Submissions and Preferred Infrastructure Report

Newcastle Inner City Bypass
Rankin Park to Jesmond

Newcastle Inner City Bypass – Rankin Park to Jesmond Submissions and preferred infrastructure report

Roads and Maritime, as the proponent of the project, has prepared this submissions and preferred infrastructure report to respond to issues raised in submissions and describe and assess design refinements made since the exhibition of the EIS.

Figure 5-11c
Drainage infrastructure

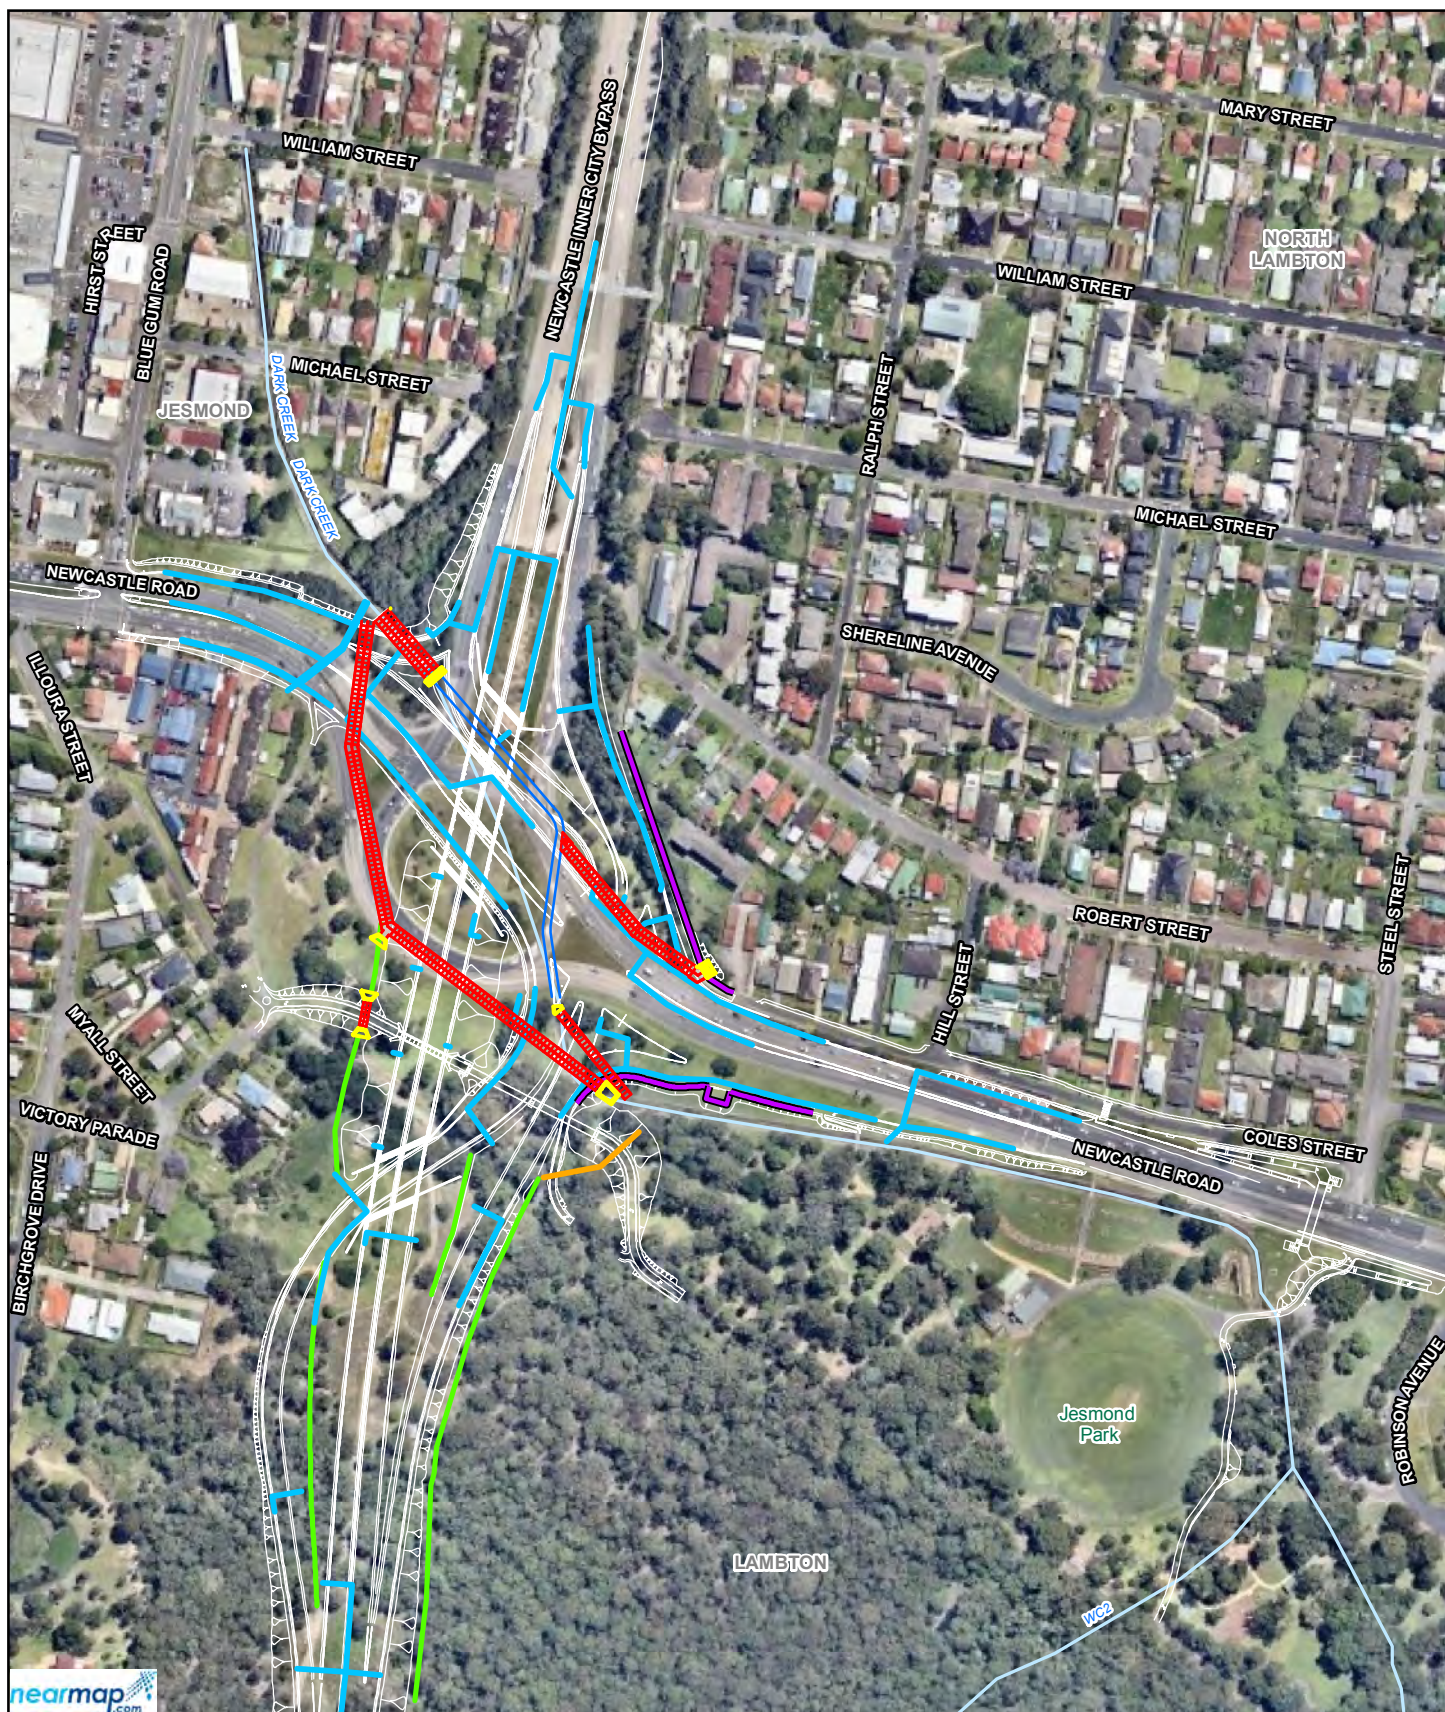
Due to the design refinements discussed in this report the proposed drainage infrastructure has now been refined as shown in Figure 5-11. The refined design is consistent with that described in the EIS and includes minor changes to cross drains, pavement drains and longitudinal catch drains to reflect other design refinements including the:

Due to the design refinements discussed in this report the proposed flood mitigation work has now been refined as shown in Figure 5-11 and consists of:

Figure 5-14
 Construction footprint

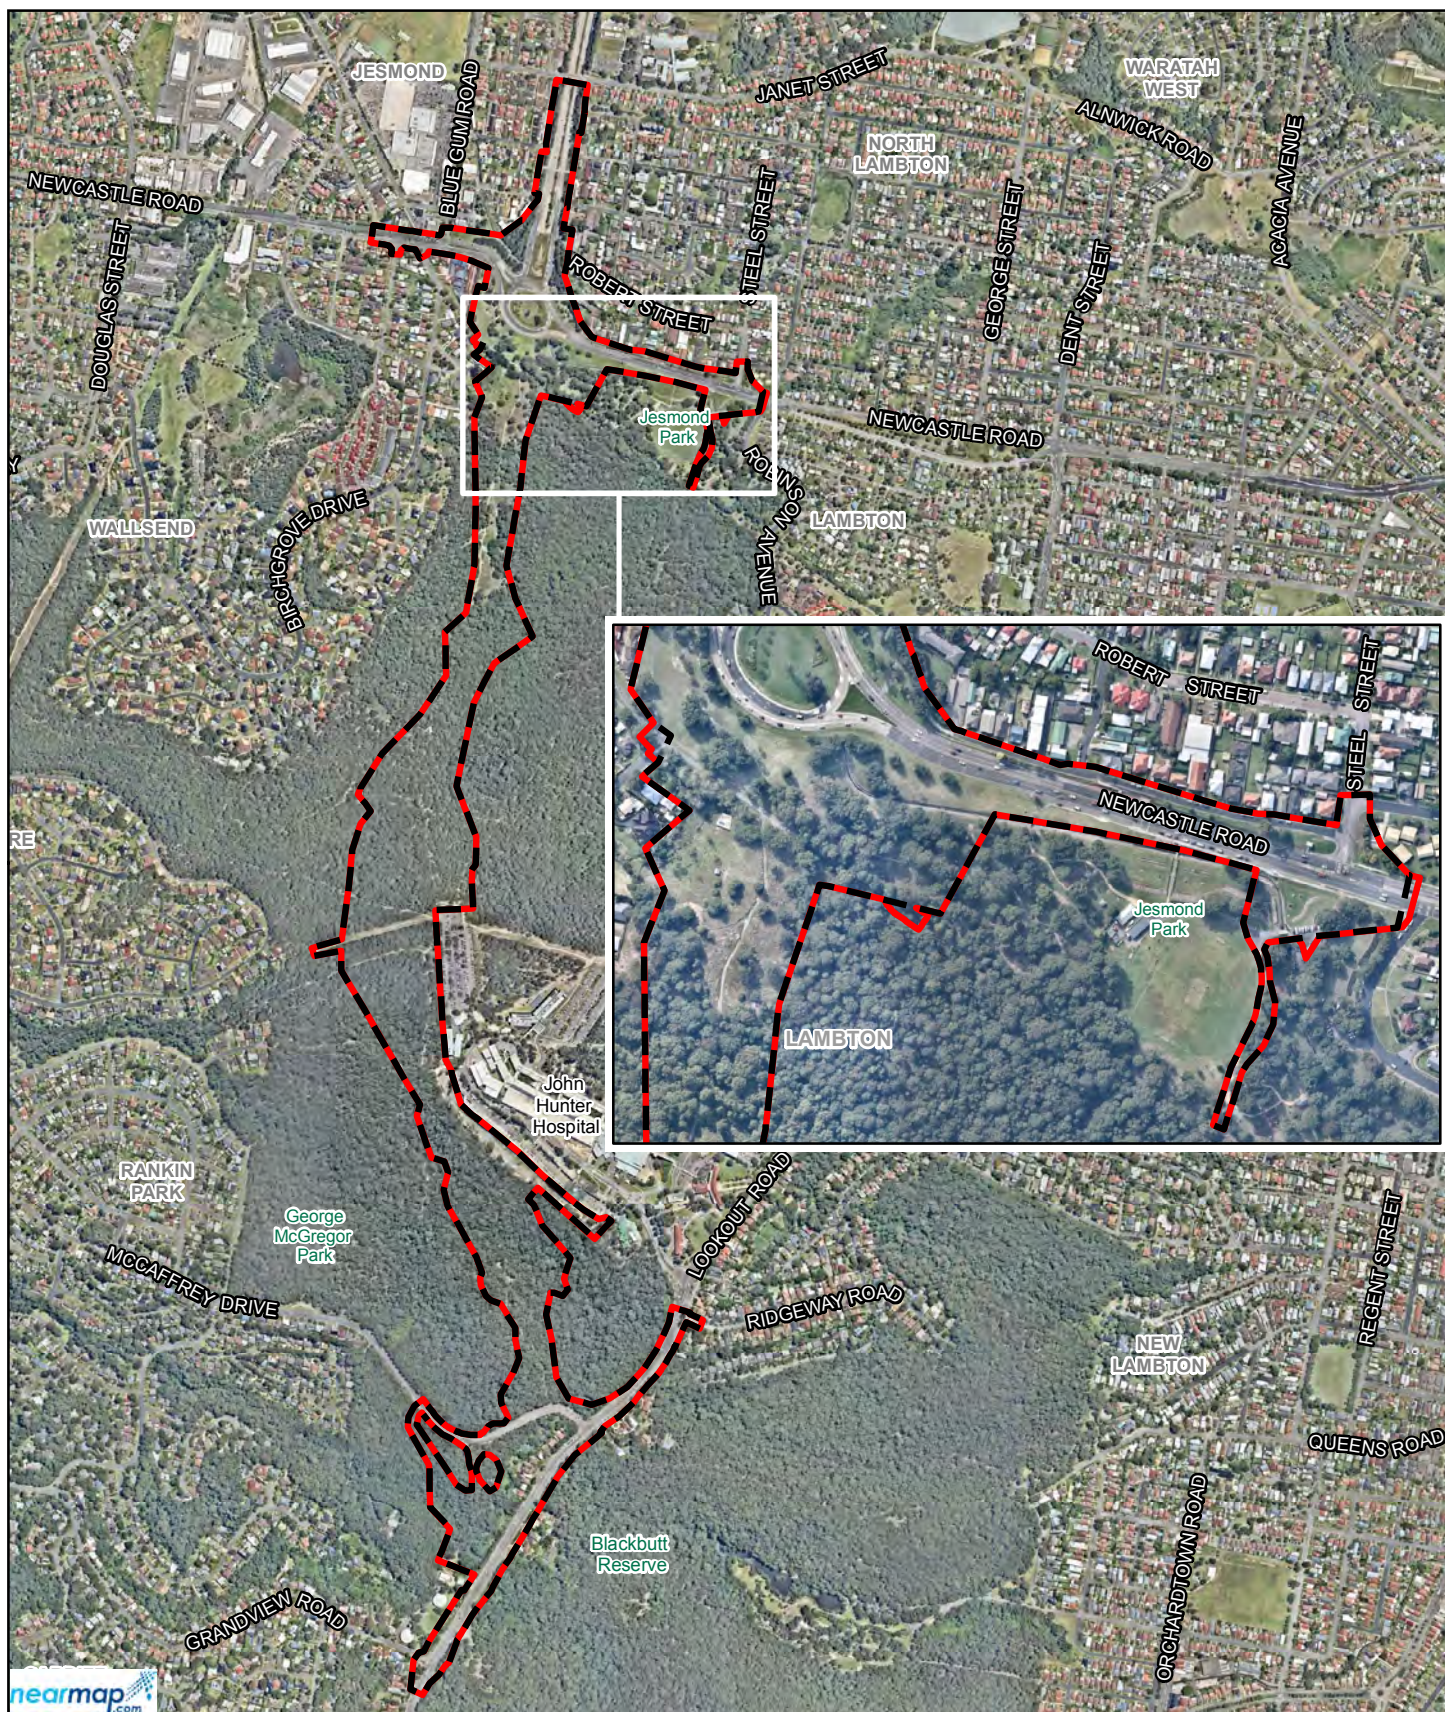
Due to project design refinements associated with the shared path connections to the bridge (Bridge 7) over Newcastle Road and grade separation of the Jesmond Park shared path (Section 5.4.2), there has been some slight adjustments to the construction footprint.

As a result the area contained within the construction footprint has increased from about 63.1 hectares to about 63.2 hectares. The refined construction footprint is shown in Figure 5-14.
